**Piper Aircraft, Inc.**  
 2926 Piper Drive  
 Vero Beach, FL, U.S.A. 32960

# SERVICE NO. 1342A BULLETIN

Service Bulletin (SB) 1342A supersedes SB 1342 in its entirety. Aircraft that were previously made compliant with SB 1342 are in compliance with SB 1342A.

**STABILATOR FITTING INSPECTION**

**Figure 1, Sheet 2 of 3**  
Stabilator Attach Fitting Assemblies

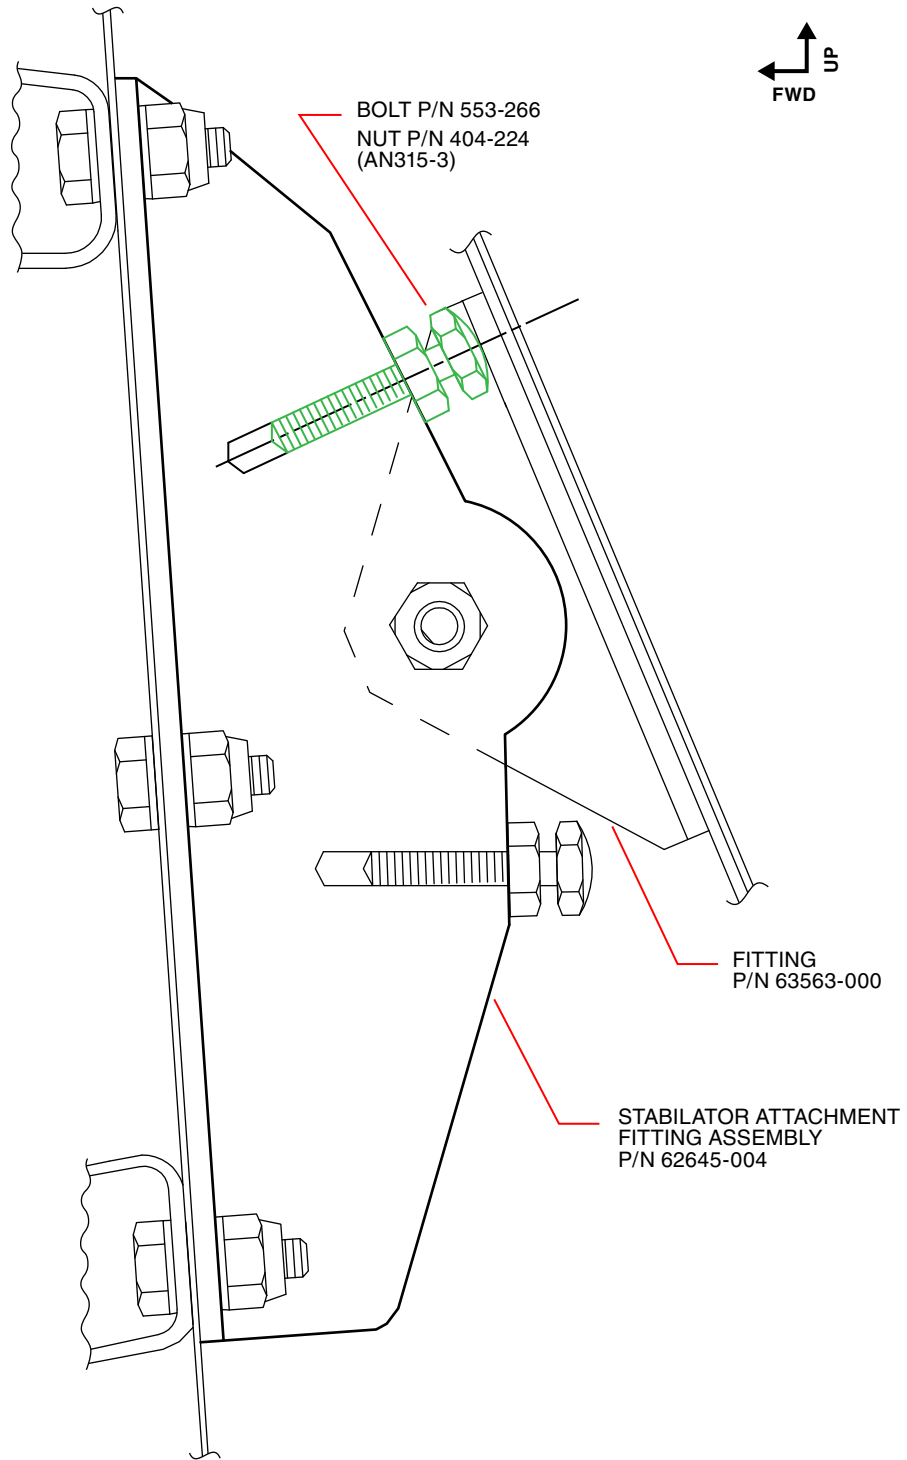
1. Take the following action, depending upon model group:
  - For airplanes listed in Group A, proceed to Step 2.
  - For airplanes listed in Group B, examine maintenance records to determine if any replacement Stabilator Attachment Fitting Assembly, Piper part number (P/N) 62645-004 was ordered between April 17 and July 30, 2019, and installed on the aircraft.
    - If so, or if maintenance records for the specified time frame are not available, proceed to Step 2.
    - If not, proceed to Step 6.
2. Gain visual access to both Stabilator Attachment Fitting Assemblies, Piper P/N 62645-004.
3. Compare the installed configuration to Figure 1, Views B–B and C–C.

If the Bolt, P/N 553-266, protrudes past the edge of the Fitting, P/N 63563-000, as shown in View C–C, then measure the distance from the edge of the fitting to the outermost portion of the bolt, as shown in View D–D.

- **Does not conform to type design:** If the measured distance, per View D–D, is 0.10 inch or greater, then the Stabilator Attachment Fitting Assembly, P/N 62645-004, must be replaced. Proceed to Step 4.

- **Conforms to type design:** Any fitting that matches View B–B conforms to type design, so replacement is not required. If the measured distance, per View D–D, is less than 0.10 inch, then replacement is not required. Proceed to Step 6.

4. Order and install one or two per airplane, as required, Stabilator Attachment Fitting Assembly, P/N 62645-004.
  - a. Remove the stabilator per Chapter 55 of the applicable Piper Airplane Maintenance Manual (AMM) or Section IV of the applicable Piper Service Manual (SM).
